2.5 W wireless charger transmitter evaluation board hardware updates

The STEVAL-ISB045V1 evaluation kit includes the STEVAL-ISB045V1T wireless battery charger transmitter evaluation board based on the STWBC-WA digital controller, firmware and the STEVAL-WBCDNGV1 USB-to-UART dongle needed to use the STSW-STWBCGUI.

To improve the board performance, we recommend to apply some changes to the STEVAL-ISB045V1 evaluation kit: replace the PMOS transistor on the bridge circuit, improve conducted EMI behavior on DC port and substitute some capacitors on the bridge circuit.

Figure 2. STL4P3LLH6 package and footprint

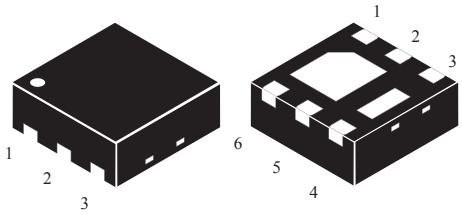
We recommend to replace the device by the new STL4P3LLH6 with the same PowerFLAT 2x2 package and same footprint.

Figure 4. STEVAL-ISB045V1 schematic diagram with new PMOS STL4P3LLH6

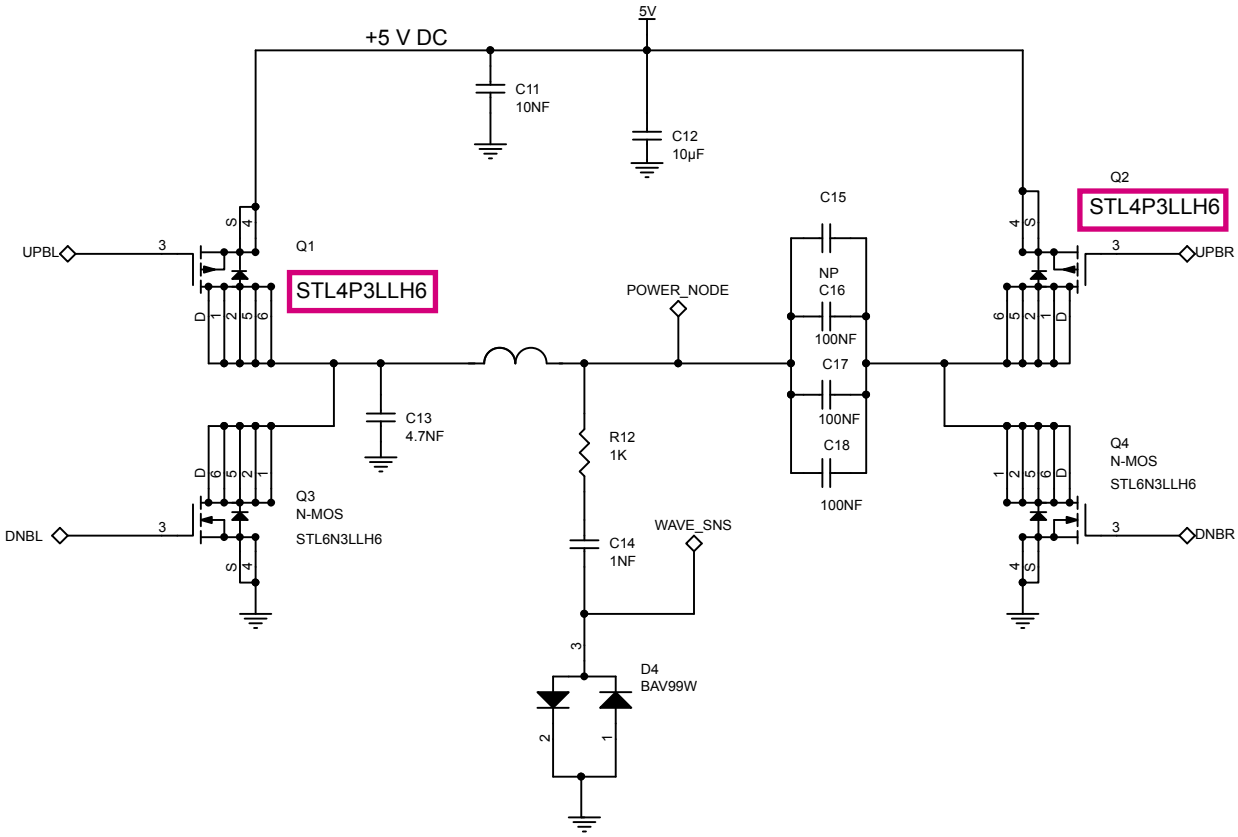
The STEVAL-ISB045V1 evaluation board is based on the STL4P2UH7 device.

Performed analysis showed no impact in replacing the old PMOS reference with the new one.

Figure 5. **STEVAL-ISB045V1 top reference designators: highlighted EMI changes**

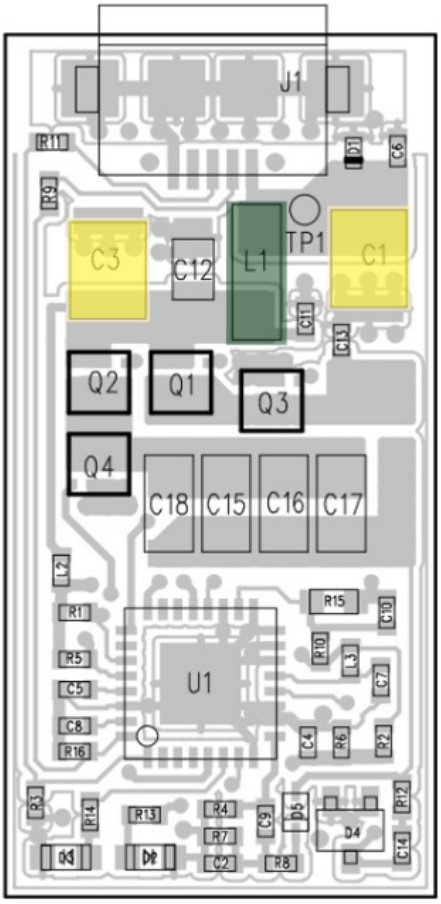
The goal of the recommended modifications is to improve the conducted EMI behavior on the STEVAL-ISB045V1 DC port.

1. Substitution of C1 capacitor (47 nF, 16 V, 1210, order code GRM32ER61C476ME15 by Wurth Elektronik) with a smaller capacitor (22 µF, order code GRM188R61A226ME15D by Wurth Elektronik). The obtained conducted EMI was degraded, so this change is not recommended.
2. Replacement of C3 with the capacitor by Murata (order code GRM188R61A226ME15D). As there was no EMI degradation, the replacement is possible.
3. Removal of L1 ferrite with no EMI conducted emission degradation as there is no limit in high frequency in conducted EMI
4. Replacement of L1 ferrite with a 2.2 µH inductor by Wurth Elektronik (order code 74479787222) resulting in a positive effect on low frequency conducted EMI, with a very small package. This replacement is recommended in case you need an improvement on EMI in the low frequency range.

Finally, the system overall performance has been tested with C3 and L1 changes and there was no impact on efficiency or behavior.

Figure 9. STEVAL-ISB045V1 top reference designators: highlighted bridge changes

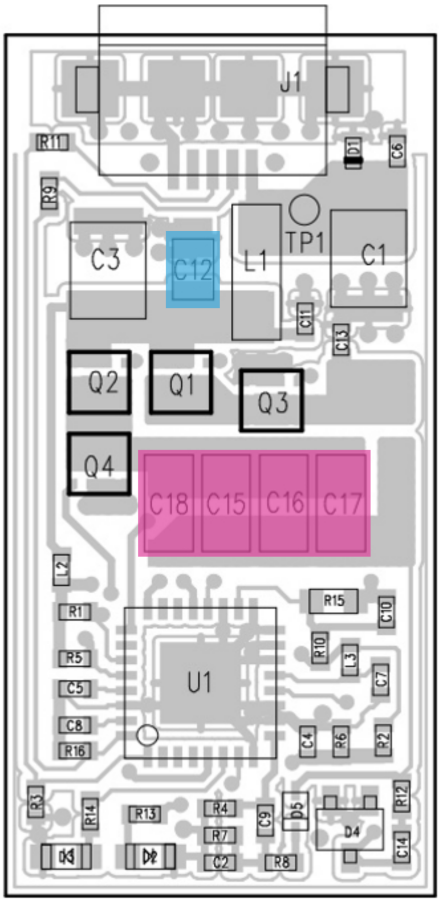
The goal of the analysis performed is to assess the impact on the overall performance when the original capacitors are replaced by components ~ 1 mm tall or lower.

No difference has been noticed by replacing C12 with the capacitor by Murata (order code GRM188R61A106KE69D).

Figure 11. STEVAL-ISB045V1 new capacitor impact on efficiency

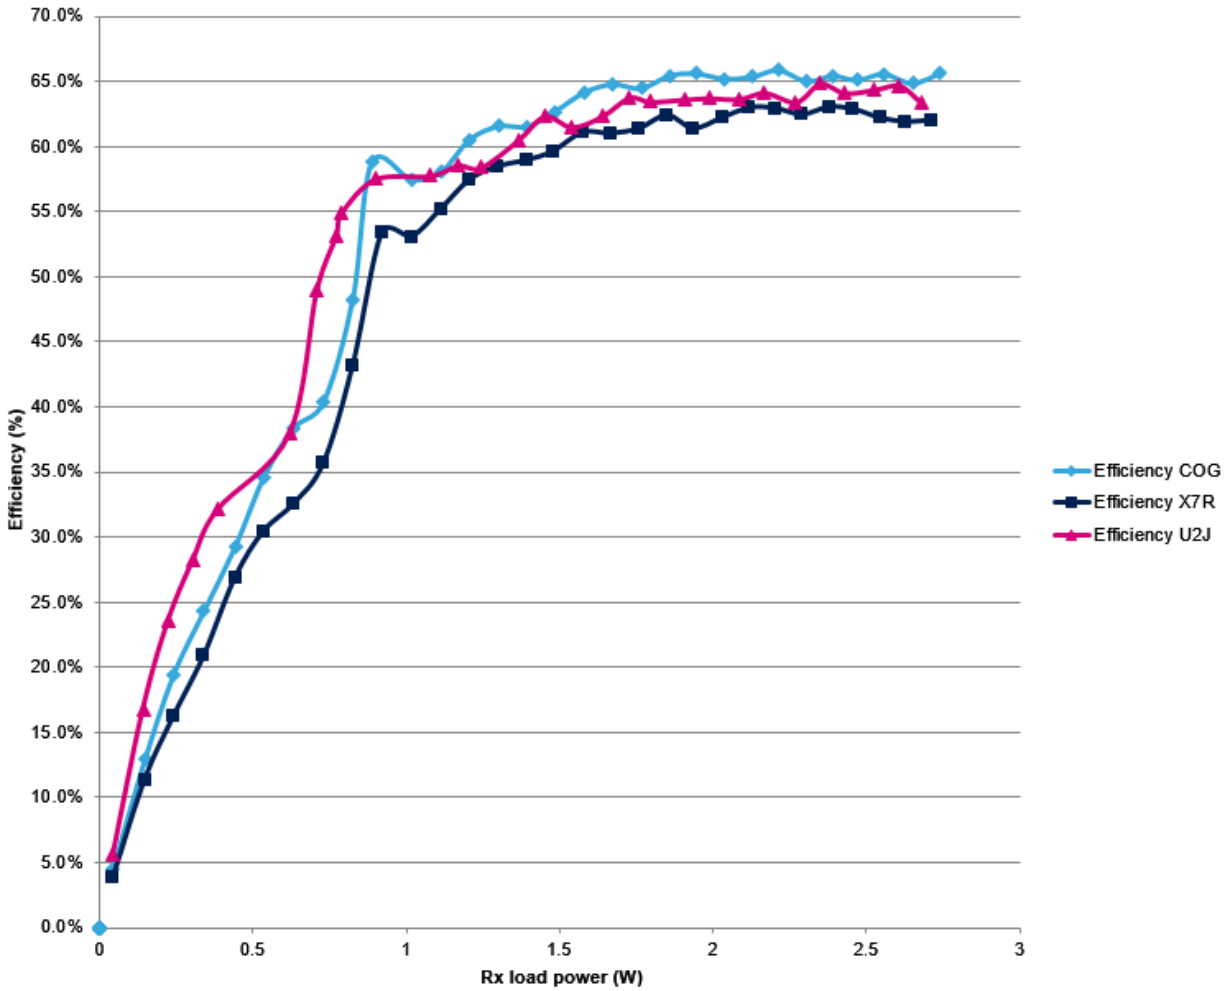
The maximum output power can be reached with all type of capacitors but capacitor technology could have an impact on the efficiency.

Important:
C3, C12, L1, Q1 and Q2 indicate hardware changes recommended, whereas C16, C17 and C18 indicate hardware changes not recommended as they have an impact on efficiency.
